THREE MILE ISLAND NUCLEAR STATION, UNIT 1

AMENDMENT TO FACILITY OPERATING LICENSE

Amendment No. 7 License No. DPR-50

ATTACHMENT TO LICENSE AMENDMENT NO. 7 CHANGE NO. 7 TO THE TECHNICAL SPECIFICATIONS FACILITY OPERATING LICENSE NO. DPR-50

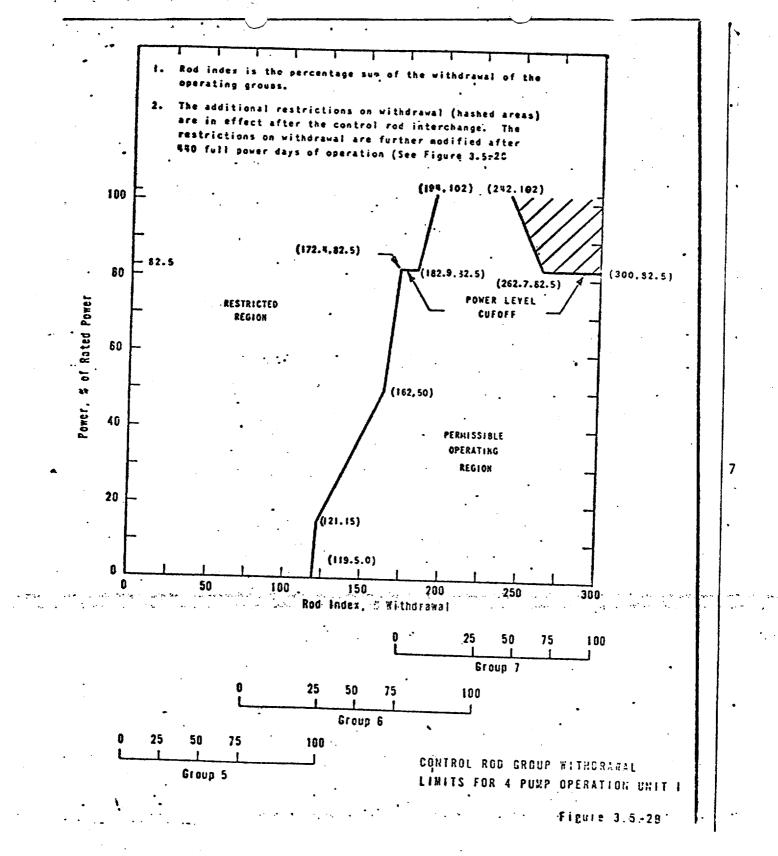
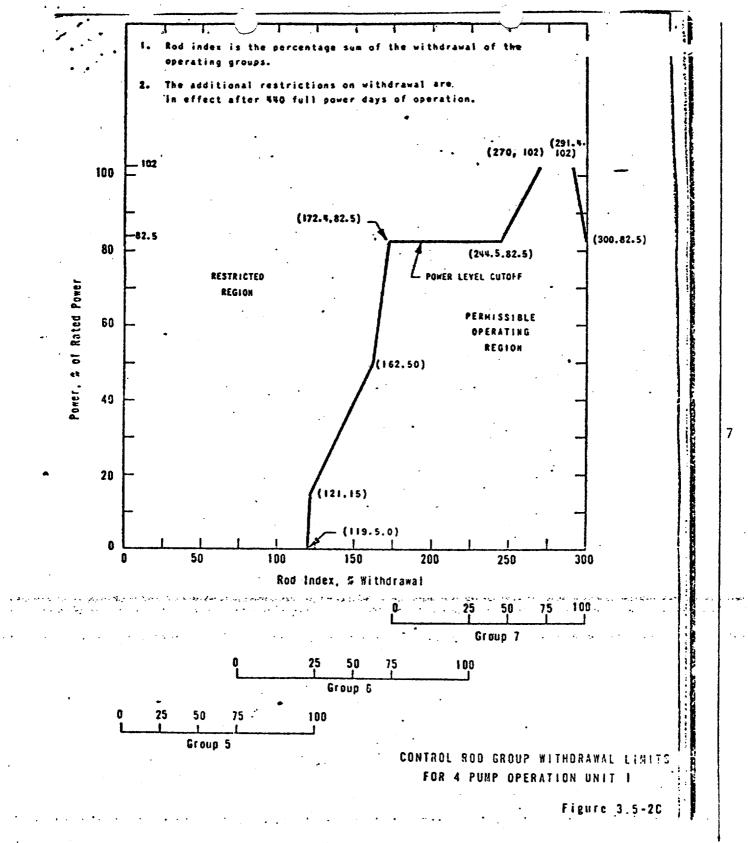
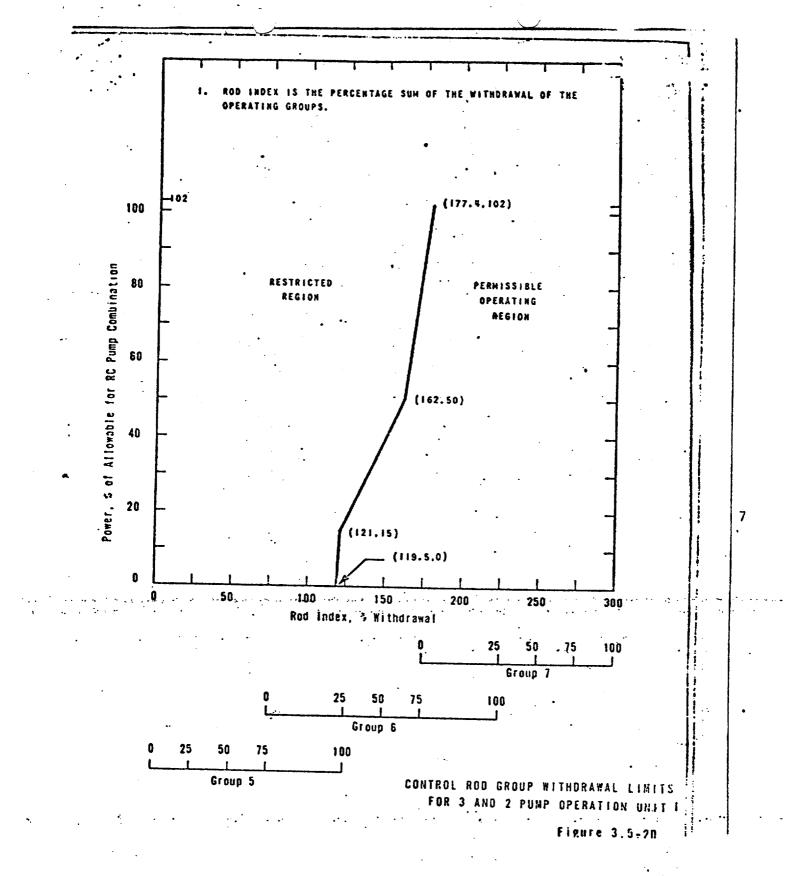
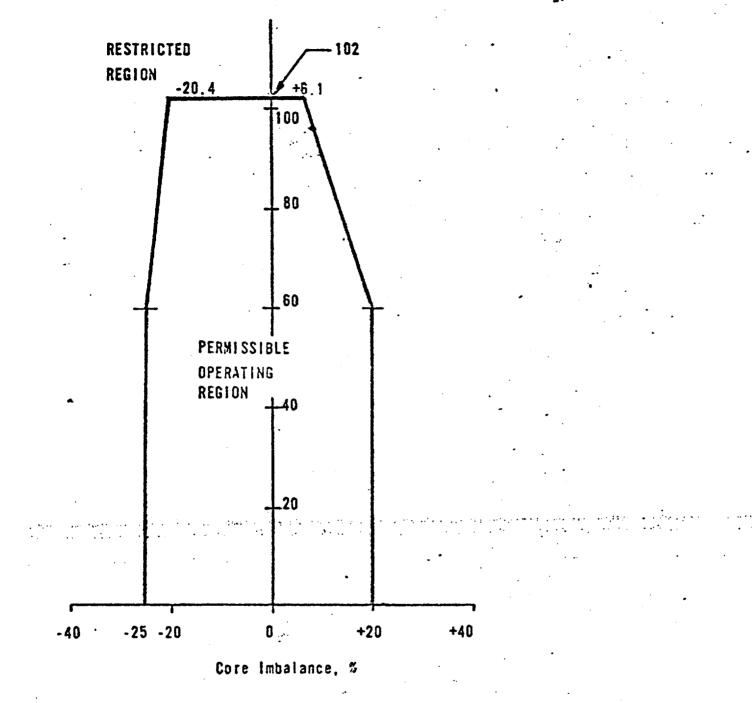
Replace figures 3.5-2A - 3.5-2B, 3.5-2C - 3.5-2D and 3.5-2E with the attached revised figures. Add figure 3.5-2F.

- a. Operating rod group overlap shall not exceed 25 percent,
 <u>+</u> 5 percent, between two sequential groups except for physics tests.
- b. Except for physics tests or exercising control rods, the control rod insertion/withdrawal limits are specified on Figures 3.5-2A (for up to the control rod interchange), Figure 3.5-2B (from control rod interchange up to 440 full power days of operation), Figure 3.5-2C (for after 440 full power days of operation) for four pump operation, and Figure 3.5-2D for three or two pump operation. If the control rod position limits are exceeded, corrective measures shall be taken immediately to achieve an acceptable control rod position. Acceptable control rod positions shall be attained within four hours.

limited by the Final Acceptance Criteria only if the control rods are at the withdrawal/insertion limits as defined by Figures 3.5-2A, 3.5-2B, 3.5-2C, and 3.5-2D and if a 4 percent quadrant power tilt exists. Additional conservatism is [7 introducted by application of:

FIGURE 3.5-2 E 7

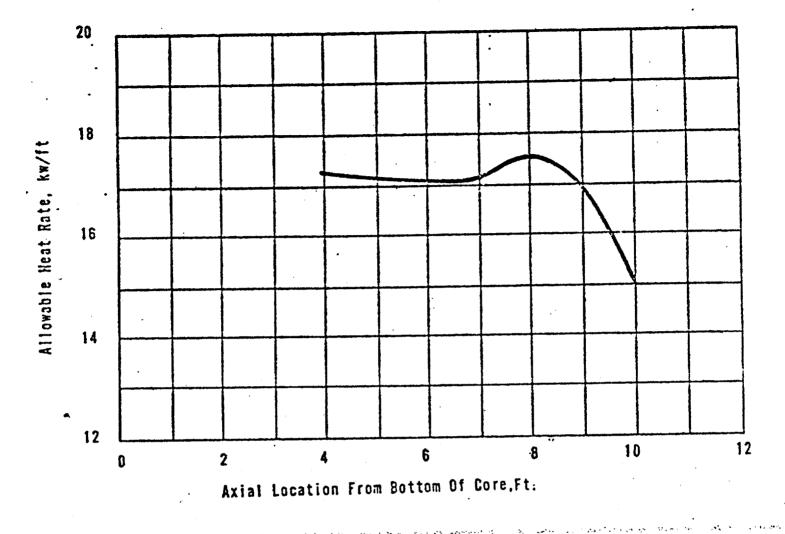
The power-imbalance envelope defined in Figure 3.5-2E is based on LOCA analyses which have defined the maximum linear heat rate (see Figure 3.5-2F) such that the maximum clad temperature will not exceed the Interim Acceptance Criteria. Operation outside of the power imbalance envelope alone does not consitute a situation that would cause the Final Acceptance Criteria to be exceeded should a LOCA occur. The power imbalance envelope represents the boundary of operation
